STATE OF NORTH CAROLINA
DEPARTMENT OF TRANSPORTATION

ADDENDUM # 2

RE: **Contract Time & Plan Sheet Revision**
Contract ID: DN00281
County: Macon
Letting Date: May 11, 2021

PROJECT REFERENCE NO. 17BP14.R.115	SHEET NO. 5
ROADWAY DESIGN ENGINEER 5/5/2021	HYDRAULICS ENGINEER 5/6/2021

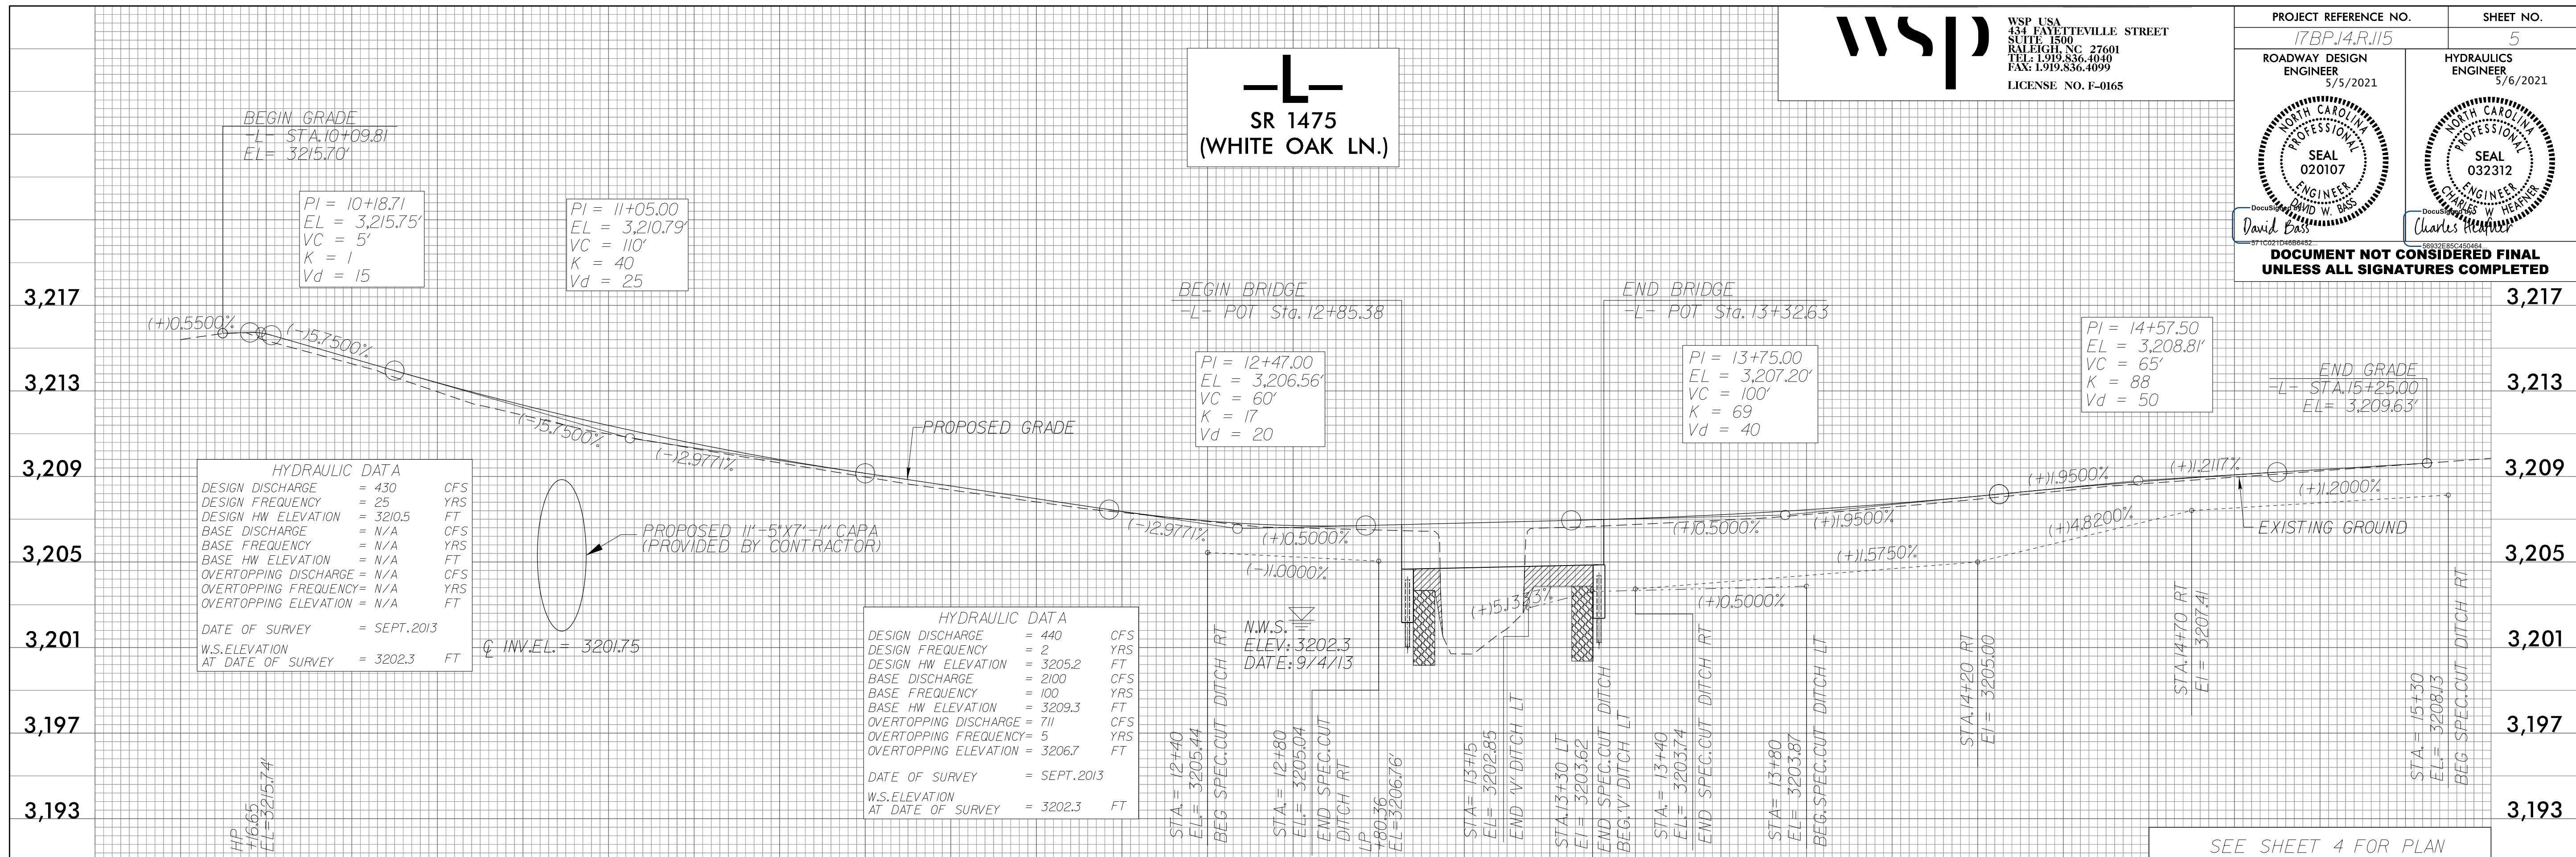
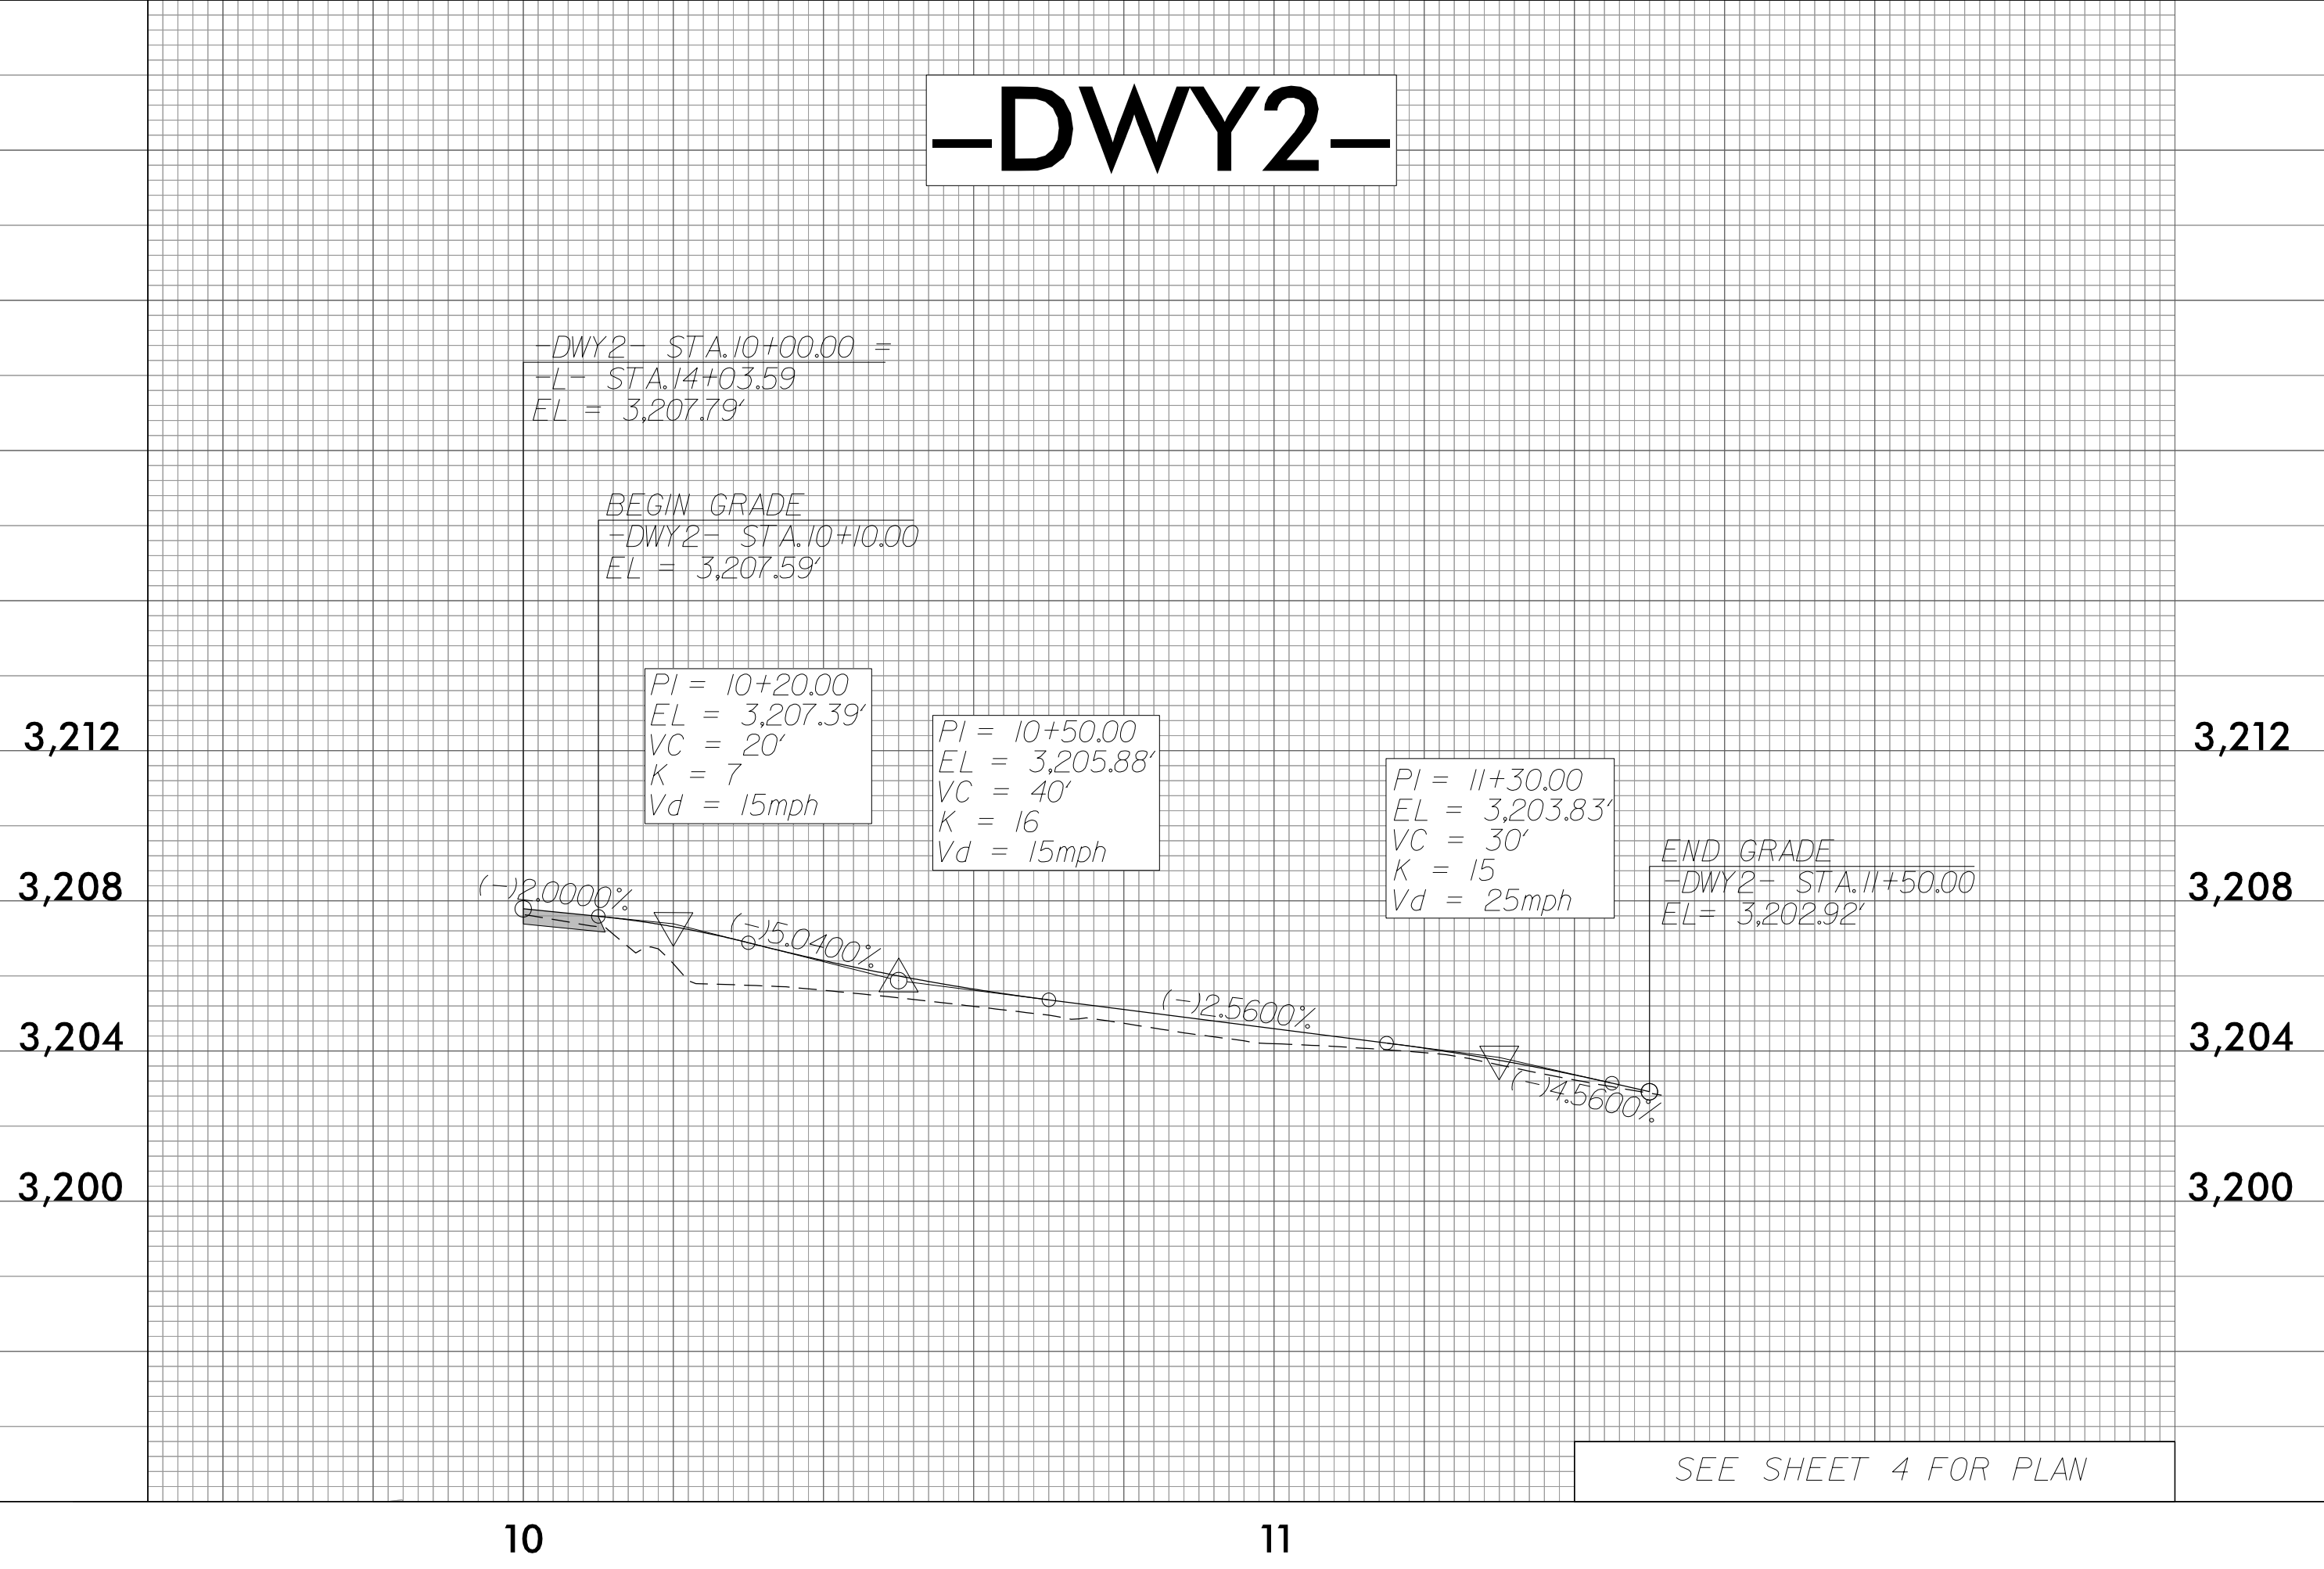
On sheet no. 5 of the DN00281 – STANDARD PDF PLANS – ROADWAY, there is a note stating that the 11'-5" x 7'-1" arch pipe will be provided by the NCDOT. This is incorrect. The arch pipe will be provided by contractor.

See attached revised sheet no. 5 showing this correction.
